Addendum Number: One Architect's Project #: 2023

CN Catoosa Child

Development Center

From: BLUE RIVER ARCHITECTS,

OVERALL FLOOR

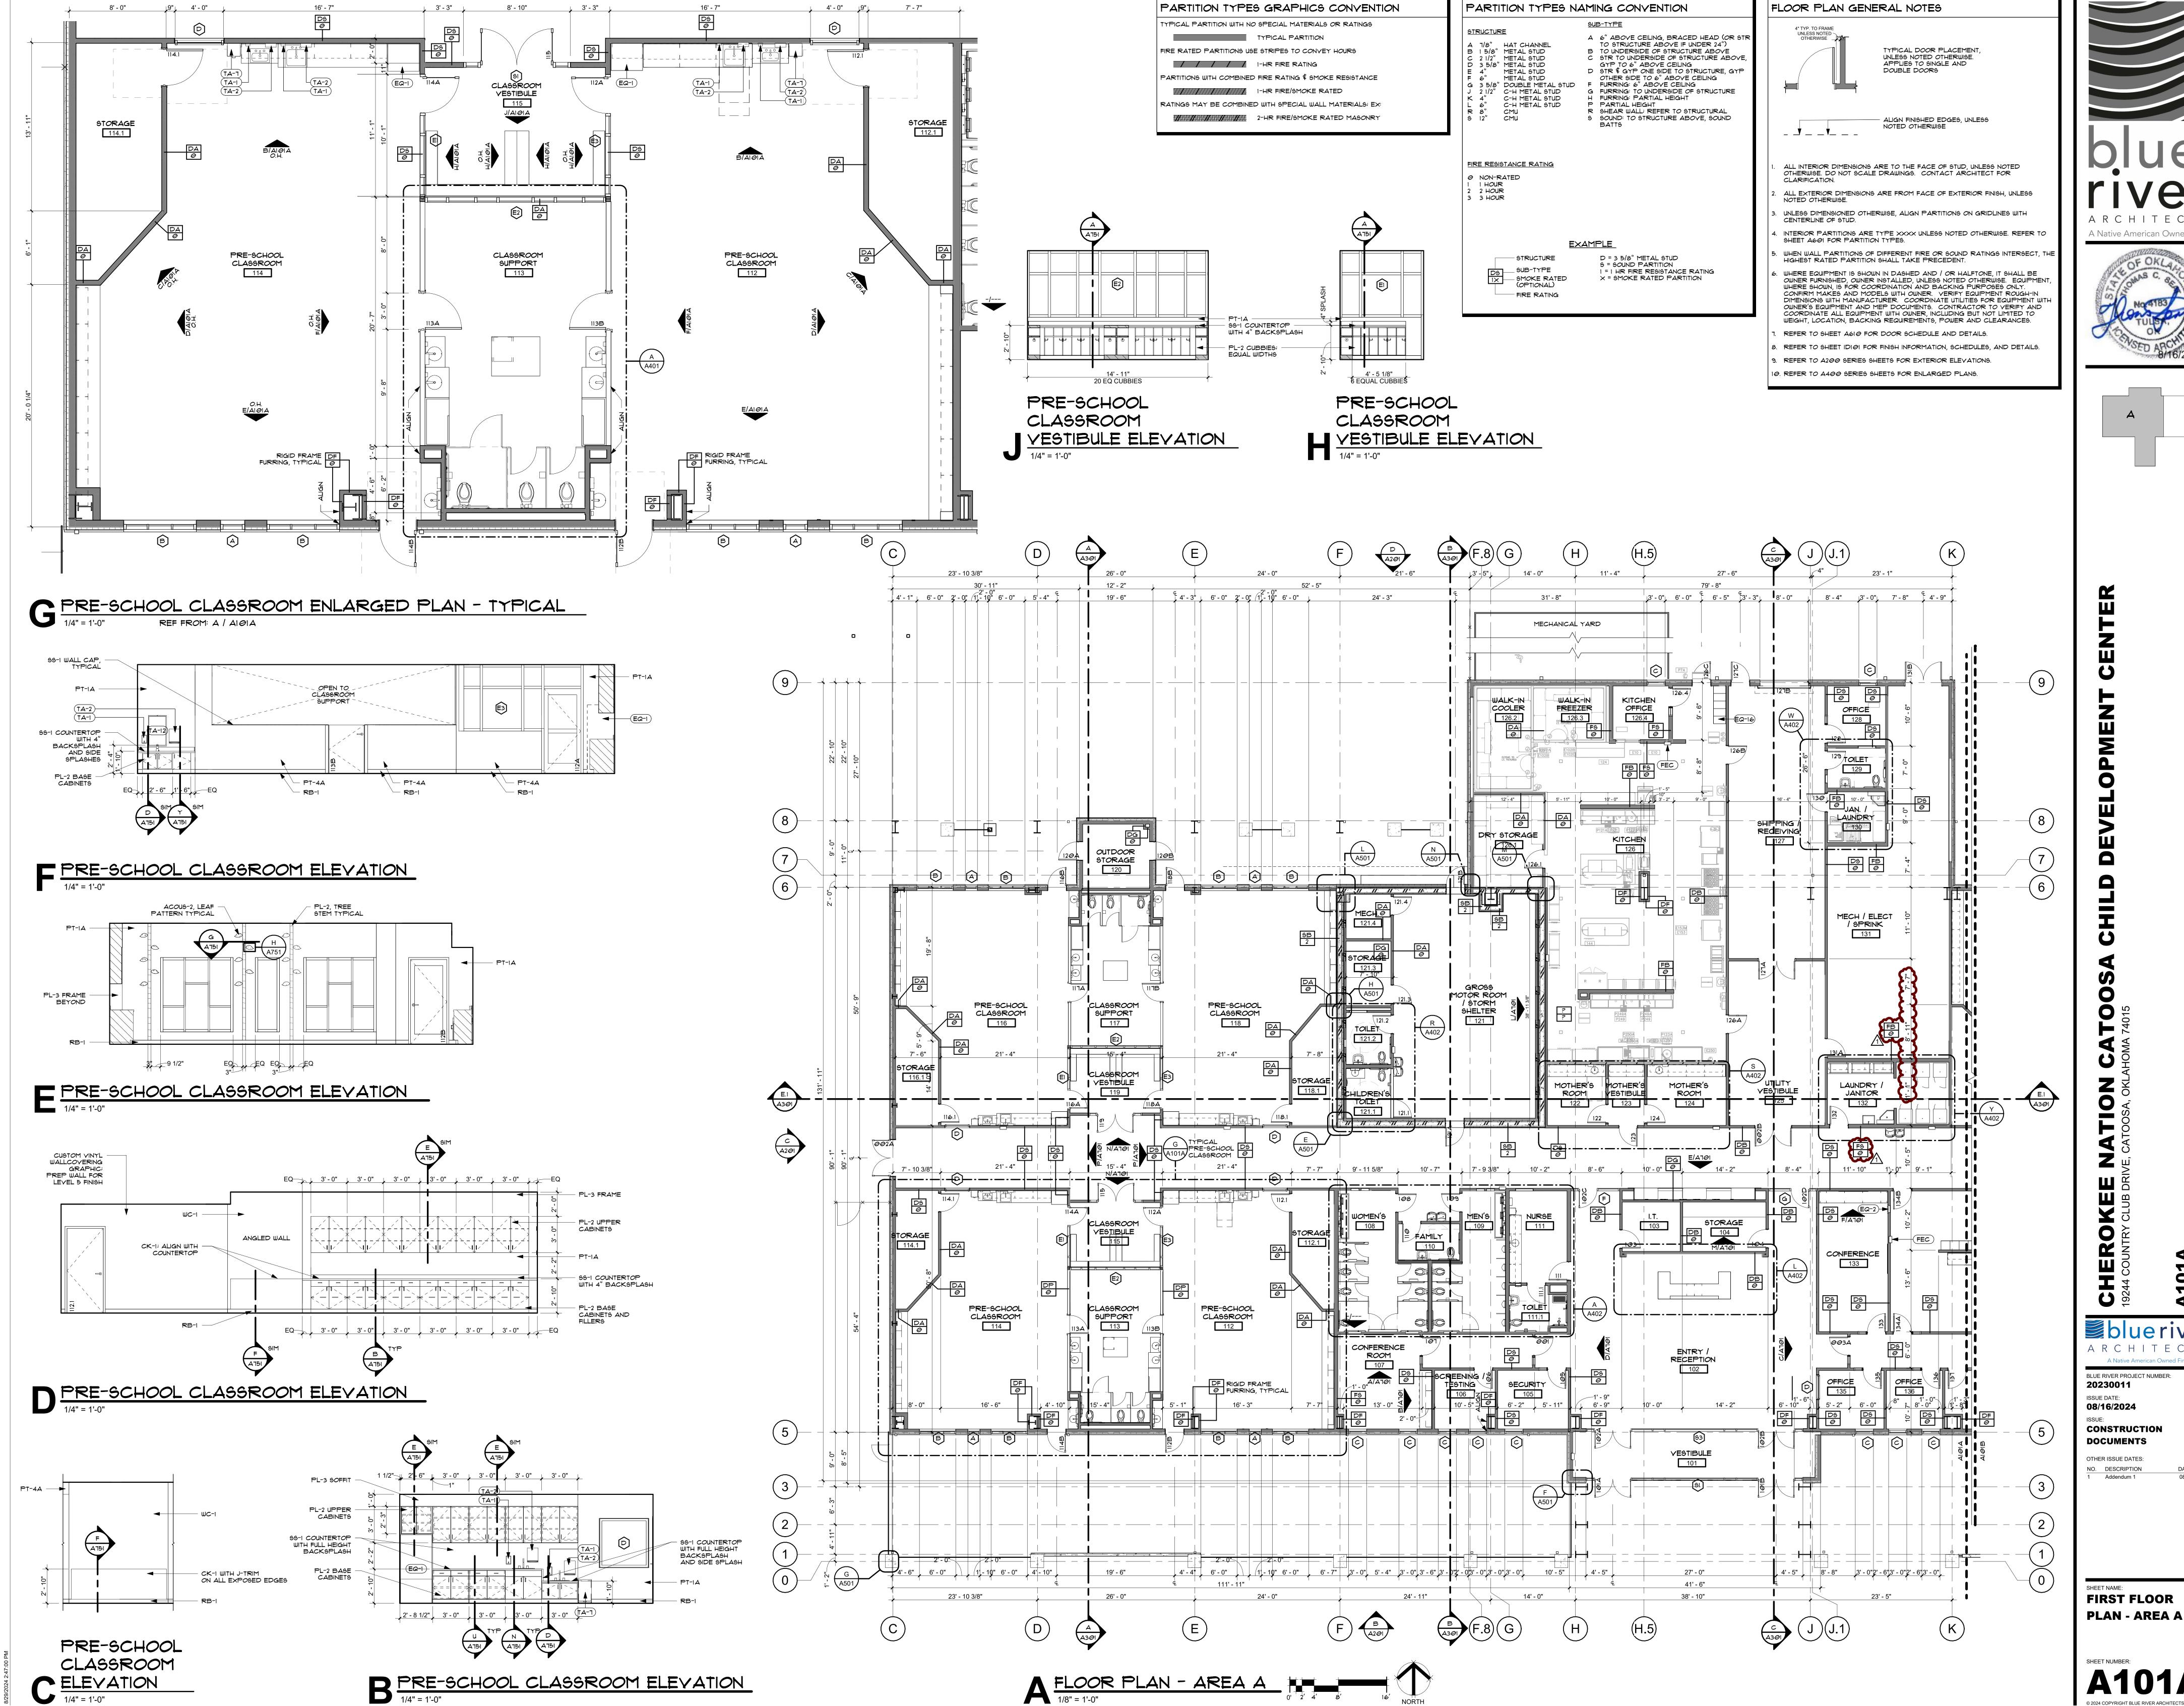
- 23. Sheet A101 Overall Floor Plan & Reflected Ceiling Plan
 - 23.1 Plans cleaned up for clarification.
- 24. Sheet A101A First Floor Plan Area A
 - 24.1 Revised wall types at Laundry/Janitor 132 and related dimensions.

SHEET NAME: **ROOF DETAILS**

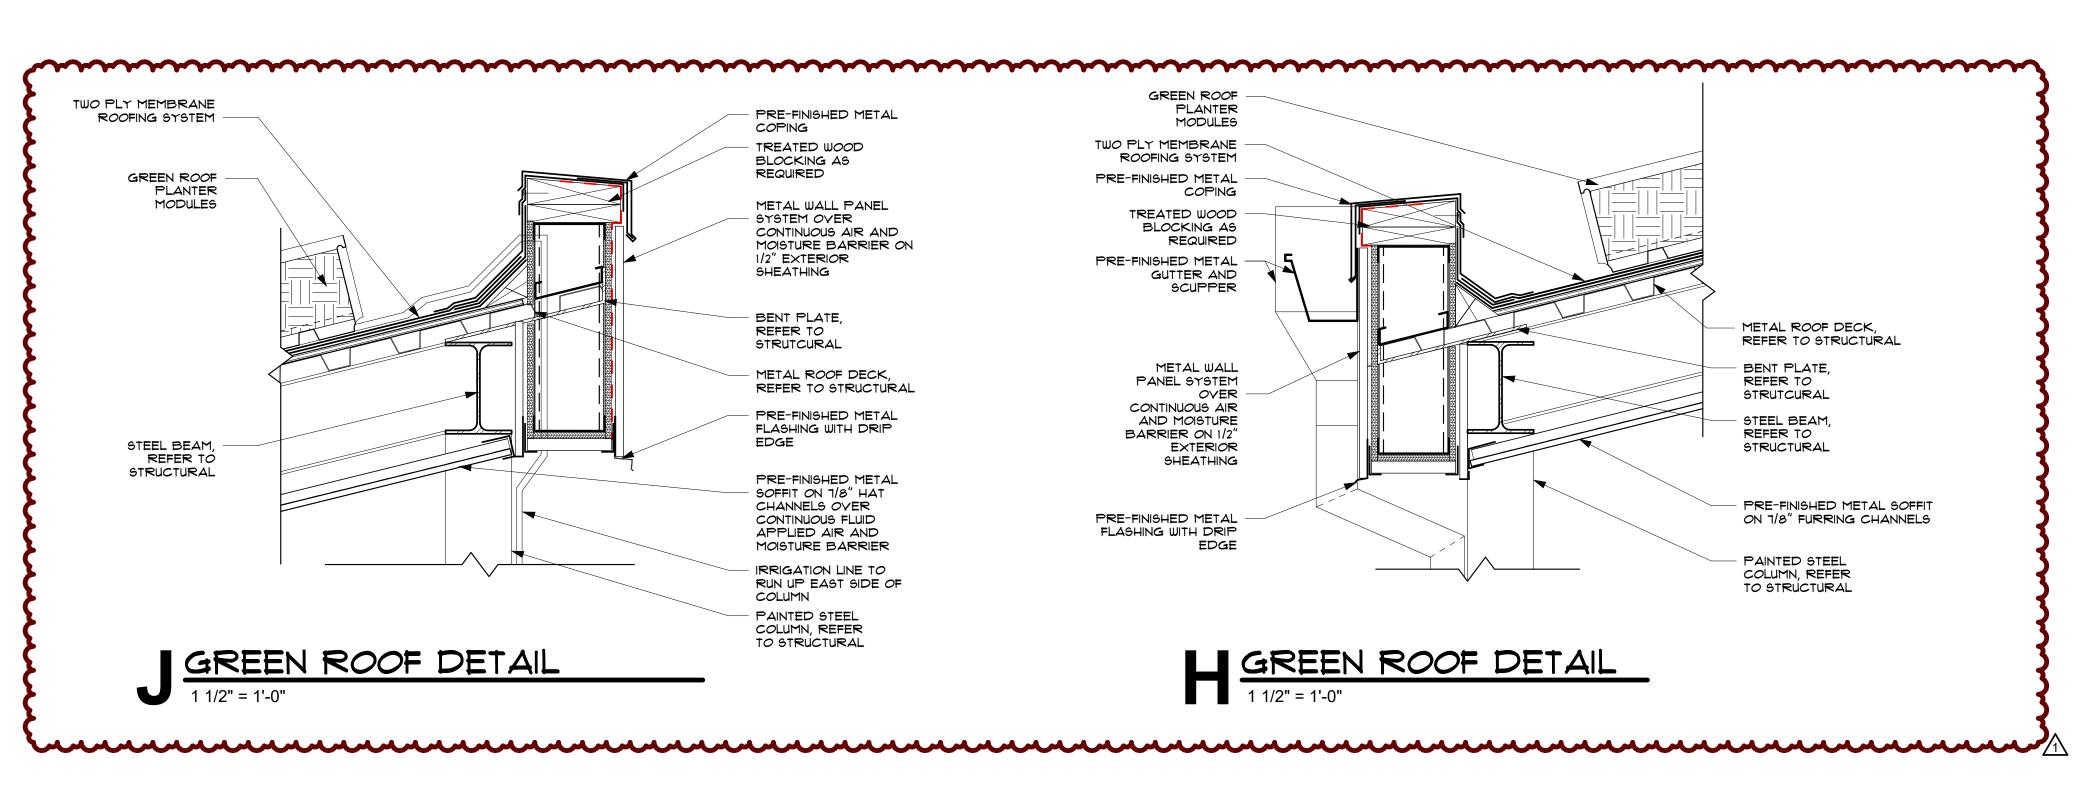
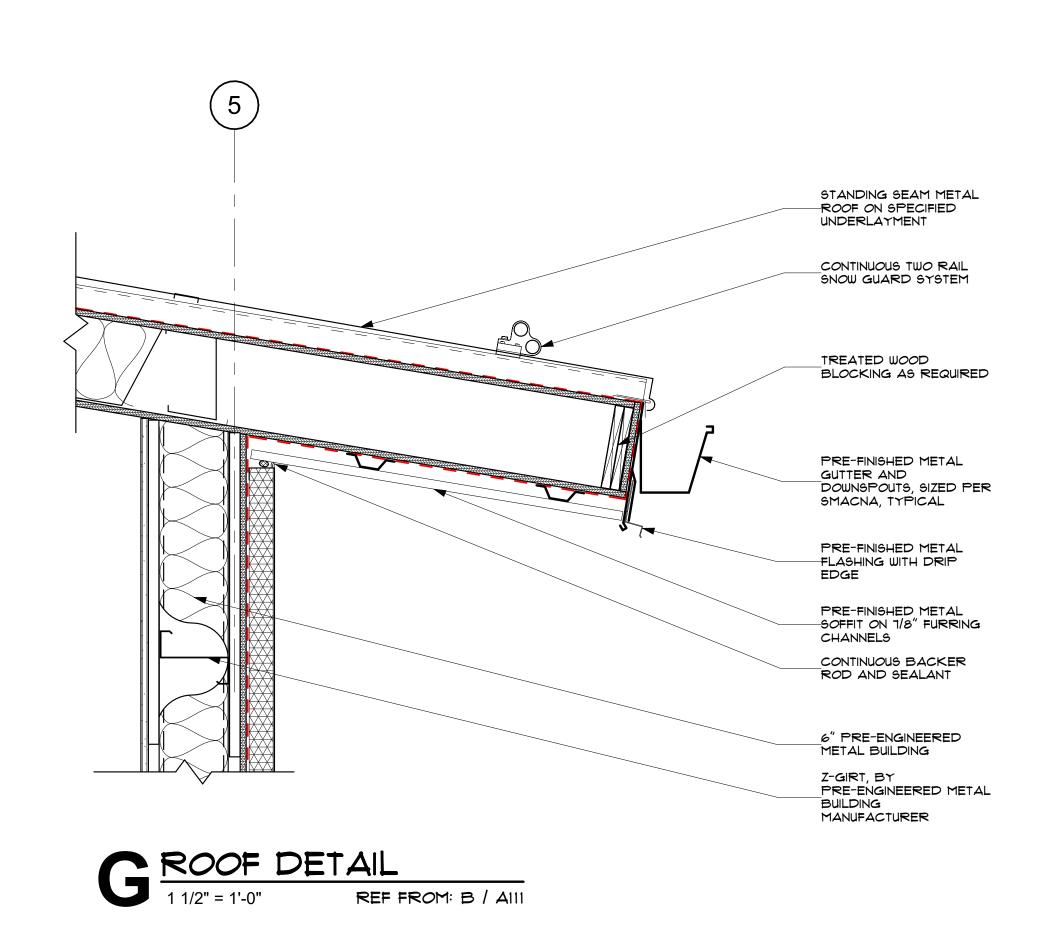
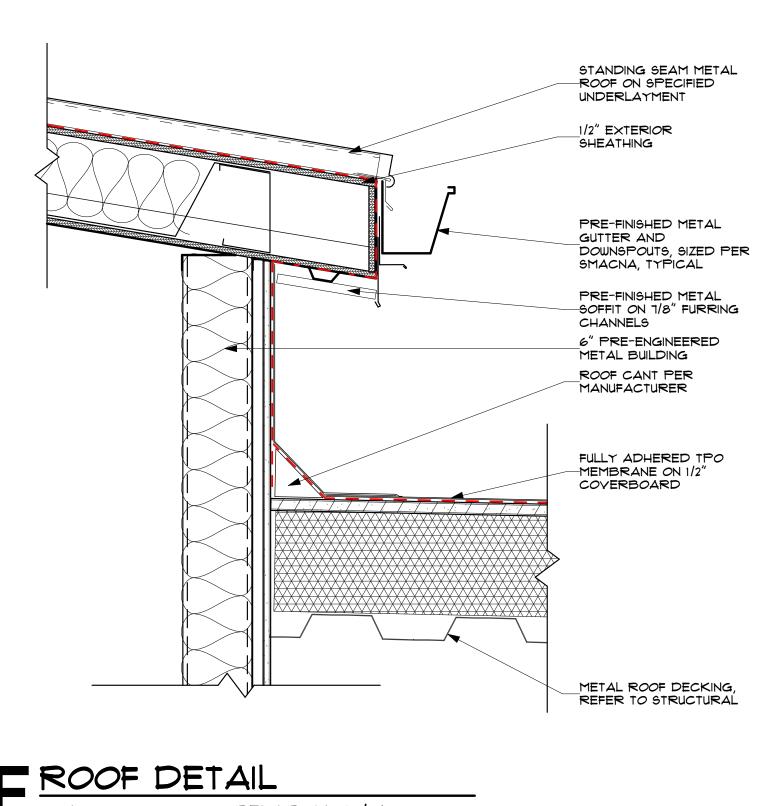
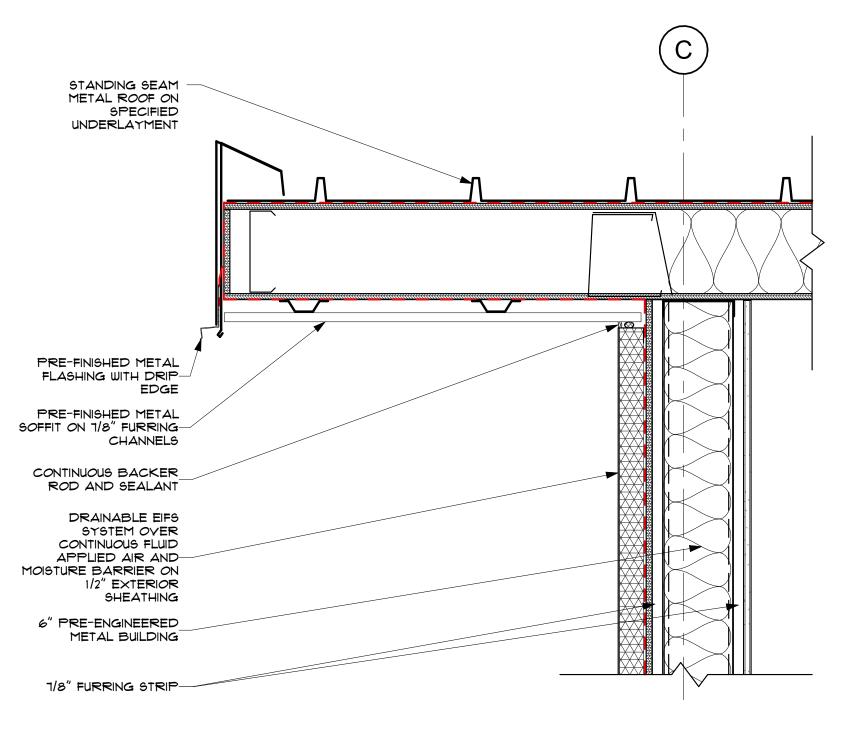
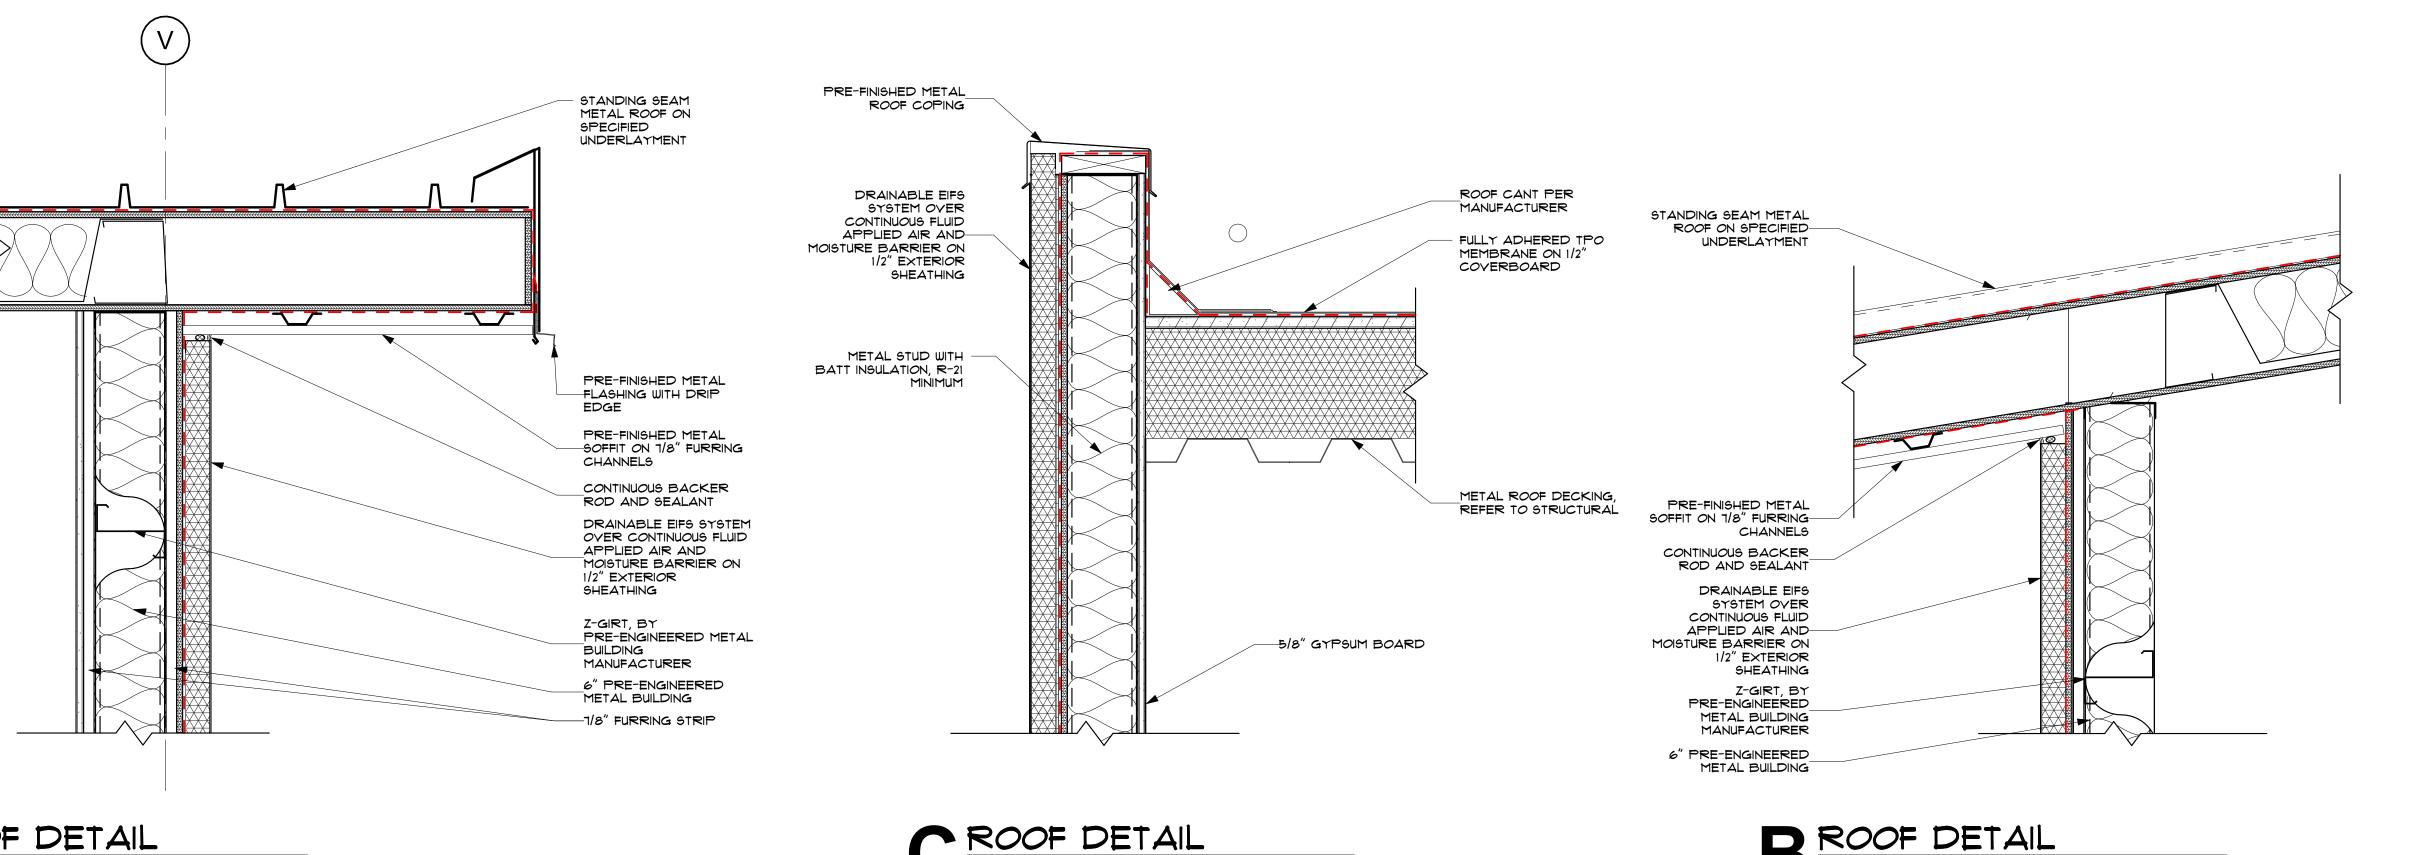
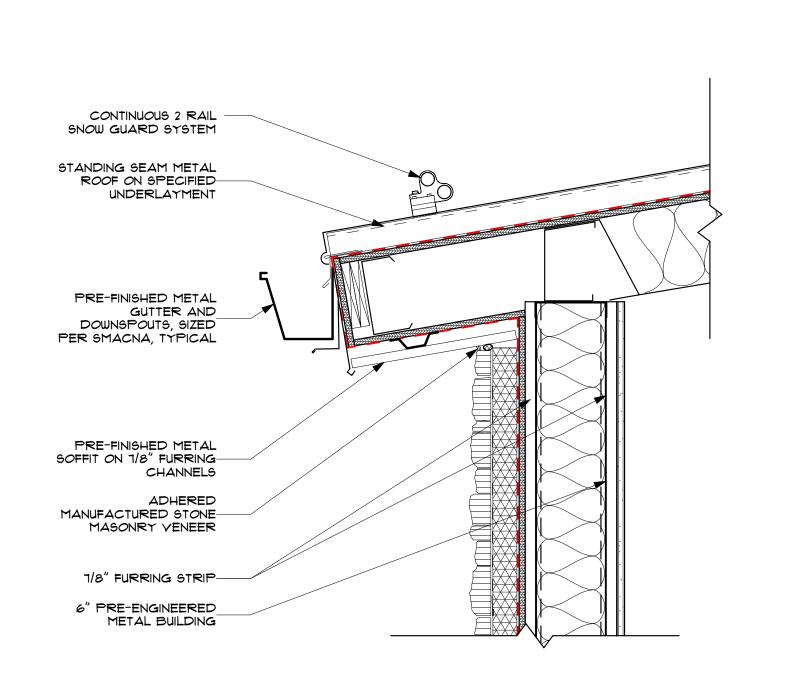
- 25. Sheet A111 Roof Plan
 - 25.1 Added green roof canopy.
 - 25.2 Revised TPO walkway layout.
- 26. Sheet A112 Roof Details
 - 26.1 Added green roof details H/ and J/A112.
